# NEW MEXICO ENERGY, MINERALS and NATURAL RESOURCES DEPARTMENT

Re: South Monument Surface Waste Facility, NMOCD permit NM-1-032

**RE: Surface Waste Management Facility Inspection Report  
South Monument Surface Waste Facility L.L.C..  
N/2 NE/4 of Section 25, Township 36 South, Range 20 East, NMPM,  
Lea County, New Mexico**

ATTACHMENT 1  
INSPECTION REPORT  
PERMIT NM-01-0032  
SOUTH MONUMENT SURFACE WASTE FACILITY, L.L.C.  
N/2 NE/4 of Section 25, Township 36 South, Range 20 East, NMPM,  
Lea County, New Mexico  
(January 24, 2003)

Photo 1. Landfarm Cell B3.

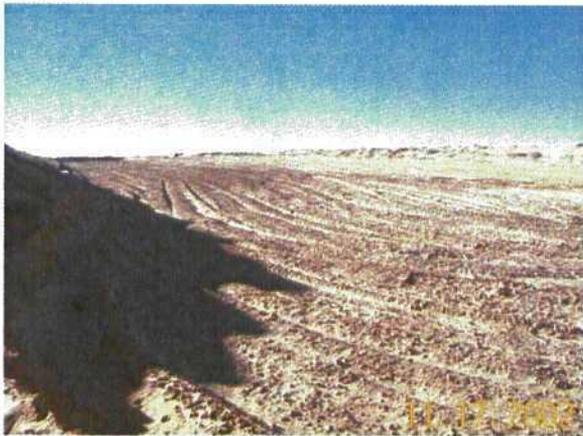
**Berms are in good shape (see photos 1, 2, 3, 4 and 5).**

**At the time of inspection soils were spread and disked accordingly (see photos 1, 2, 3, 4 and 5).**
